LSC Responses to TIS Redline Comments

Sterling Ranch Sketch Plan 2023 Amendment & Rezone Traffic Technical Memorandum (LSC #S224441) September 28, 2023

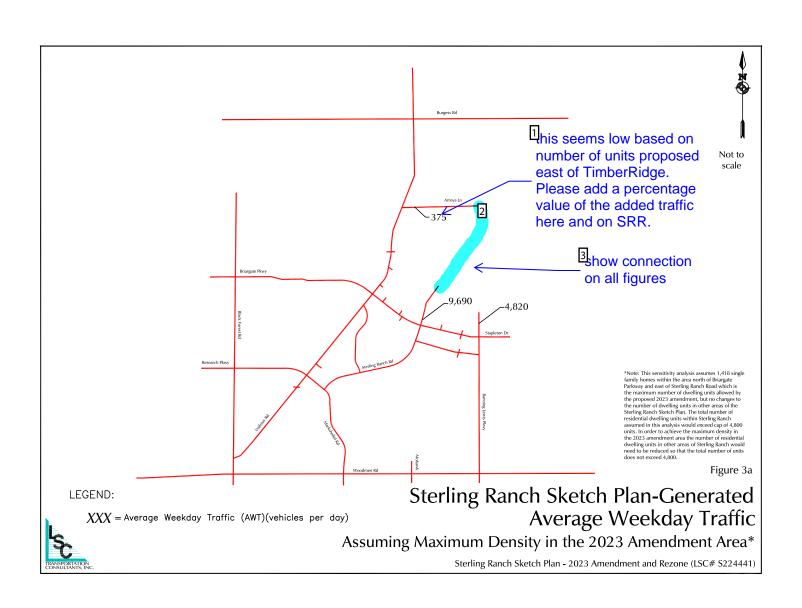
Address how Sterling Ranch Road will be connected to Arroya Lane and the anticipated classification of Arroya, and with the additional density in this area how this increases the possibility of the ultimate east-west connection of Arroya Lane along the north side of Sterling Ranch (if the property to the north subdivides).

Author: kdferrin Subject: Sticky Note Date: 12/15/2023 9:37:39 AM LSC Response: The additional information has been added as requested.

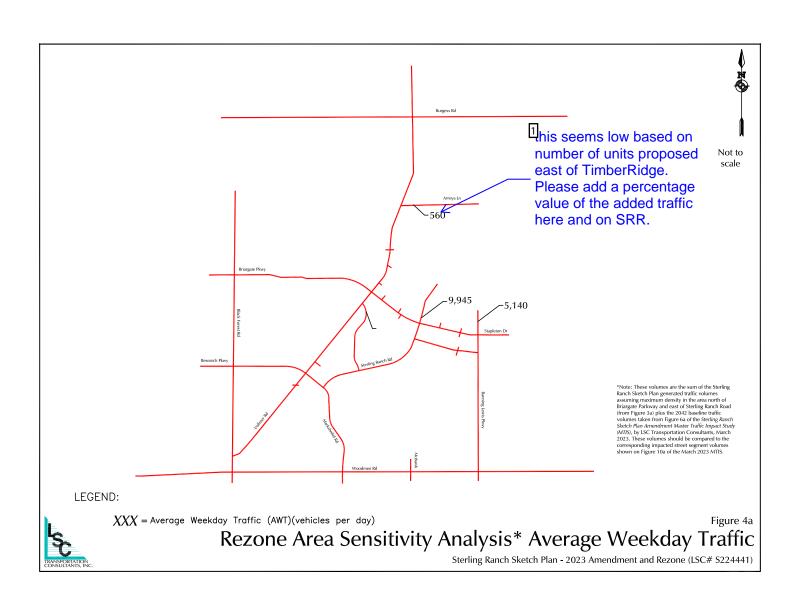
Number: 1 Author: Jeff Rice - EPC Engineering Review Subject: Callout Date: 11/1/2023 2:08:12 PM -06'00' this seems low based on number of units proposed east of TimberRidge. Please add a percentage value of the added traffic here and on SRR. Author: kdferrin Subject: Sticky Note Date: 12/15/2023 9:37:48 AM LSC Response: The additional information has been provided as requested. Number: 2 Author: Jeff Rice - EPC Engineering Review Date: 11/1/2023 2:06:37 PM -06'00' Author: Jeff Rice - EPC Engineering Review Number: 3 Subject: Callout Date: 11/1/2023 2:08:14 PM -06'00'

show connection on all figures

LSC Response: The figures have been updated as requested.

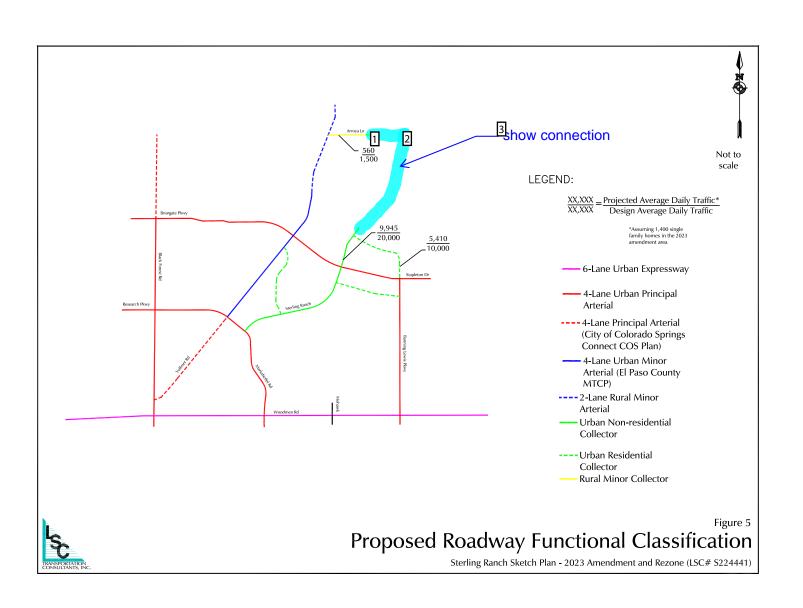
this seems low based on number of units proposed east of TimberRidge. Please add a percentage value of the added traffic here and on SRR.

Number: 1	Author: Jeff Rice - EPC Engineering Review	Date: 11/1/2023 2:05:26 PM -06'00'		
Number: 2	Author: Jeff Rice - EPC Engineering Review	Date: 11/1/2023 2:05:22 PM -06'00'		
Number: 3	Author: Jeff Rice - EPC Engineering Review	Subject: Callout	Date: 11/1/2023 2:05:36 PM -06'00'	
show conn	ection

Author: kdferrin Subject: Sticky Note Date: 12/15/2023 9:38:05 AM LSC Response: The additional information has been provided as requested.

Author: kdferrin Subject: Sticky Note Date: 12/15/2023 9:38:10 AM LSC Response: The figures have been updated as requested.
